Title of Change:	Datasheet Update with Correct Case Outline
Effective date:	17 May 2023
Contact information:	Contact your local onsemi Sales Office or guokun.yeng@onsemi.com
Type of notification:	This Product Bulletin is for notification purposes only. onsemi will proceed with implementation of this change upon publication of this Product Bulletin.
Change Category:	Datasheet
Change Sub-Category(s):	Datasheet/Product Doc change

This product bulletin is to announce datasheet update with correct case outline information.

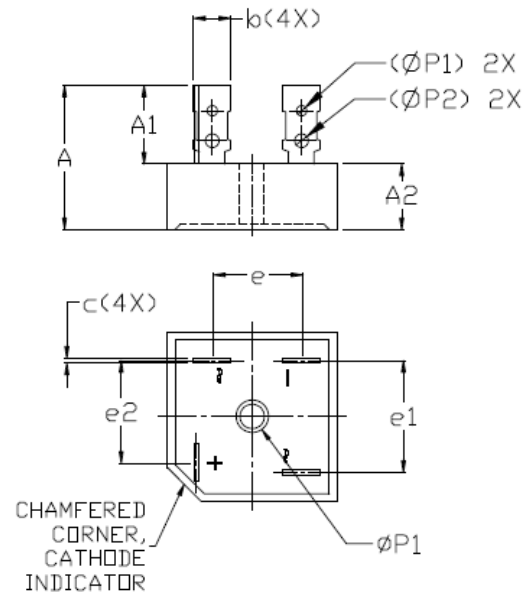
Before				After			
DIM	MILLIMETERS			DIM	MILLIMETERS		
	MIN	NOM	MAX		MIN.	NOM.	MAX.
A	28.50	28.75	29.00	A	21.500	23.000	24.500
B	13.325	14.375	15.425	A1	13.270 REF		
C	5.08	5.335	5.59	A2	10.970	11.100	11.230
D	28.50	28.75	29.00	øP	5.080	5.335	5.590
E	15.50	16.55	17.60	øP1	1.780 REF		
F	13.30	14.30	15.30	øP2	2.360 REF		
G	17.10	18.10	19.10	D	28.500	28.750	29.000
H	~	~	6.35	E	28.500	28.750	29.000
I	10.97	11.10	11.23	b	6.350 TYP		
J1	21.50	23.00	24.50	c	0.760	0.810	0.860
J2	30.50	~	~	e	13.300	14.300	15.300
øK	2.39 BSC			e1	17.100	18.100	19.100
øL	3.41 BSC			e2	15.500	16.550	17.600
øM	0.97	1.02	1.07				
O	0.71	0.81	0.91
